Dynamic Containment Terms and Conditions

Amendment of EBGL Article 18 mapping for Dynamic Containment Terms and Conditions requirements

EBGL Article 18 Dynamic Containment Terms and Conditions Consultation Responses summary

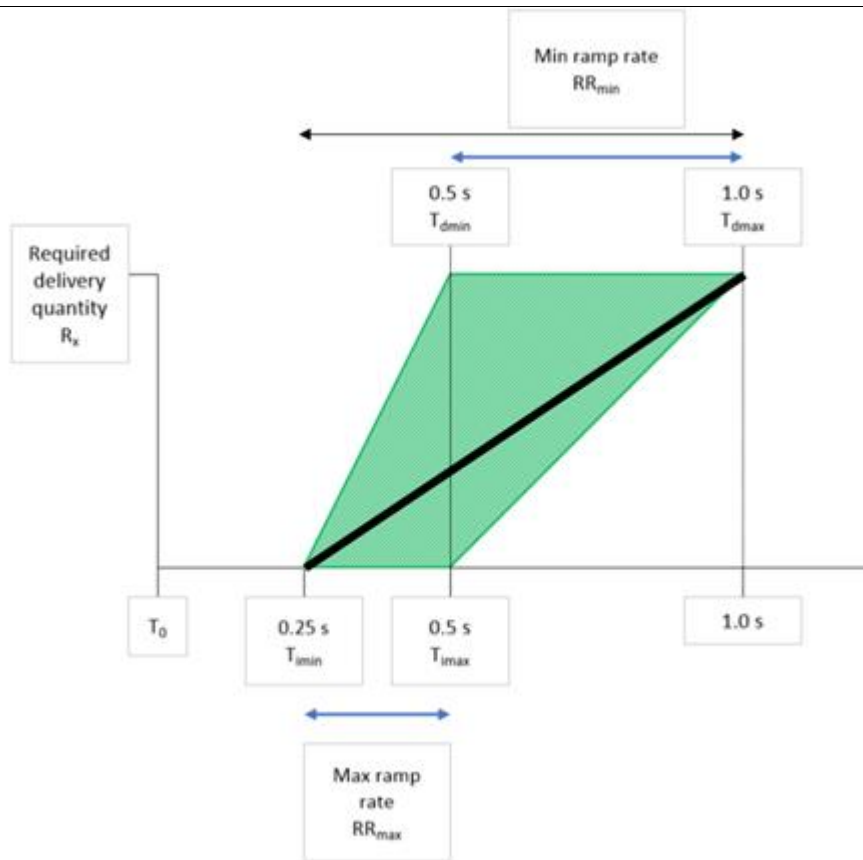
| Respondent | Response or Key Theme | NGESO Comments |
|-------------------|--|---|
| Fraser Norris | <p>Q4. Do you have any other comments in relation to the proposal?</p> <p>Minimum Ramp Rate for Response Delivery Page 16 of the Service Terms document defines the minimum ramp rate for response delivery as</p> $RR_{Min} = RXTd_{Max} - Ti_{Max}$ | <p>NGESO would like to thank Fraser Norris for their response.</p> <p>We appreciate the graphic is potentially misleading as it is trying to illustrate a number of different elements, however the formula on page 16 of the Service Terms is correct.</p> |

Figure 20 in the Testing Guidelines document relates to Test 2.2. It doesn't look like the minimum delay of 0.25s has been observed once the frequency drops below the threshold of 50.5Hz. Please can you confirm this?

| | <p>where</p> <p style="text-align: center;">$TdMax$</p> <p>is 1.0s and</p> <p style="text-align: center;">$TiMax$</p> <p>is 0.5s. The description states that</p> <p style="text-align: center;">$RRMin$</p> <p>is "the slowest ramp rate acceptable between change in response delivery and reaching the required delivery quantity". This description makes it very clear that a response rate slower than this is considered unacceptable, but can you confirm that the formula wasn't intended to be</p> <p style="text-align: center;">$RRMin = RXTdMax - TiMin$</p> <p>where</p> <p style="text-align: center;">$TiMin$</p> <p>is 0.25s. This would result in the minimum ramp rate possible within the area highlighted green in the response figure below.</p> | <p>Regarding Testing guidance</p> <p>Test 2.1 and 2.2 have been amended in the testing guidance and analysis tool to reflect the 0.25 minimum delay. The tolerance bands now reflect the time to reach the required delivery</p> <p>Table 5 has now been amended with all references to "b" removed. The table has also been simplified to be more user friendly format</p> |
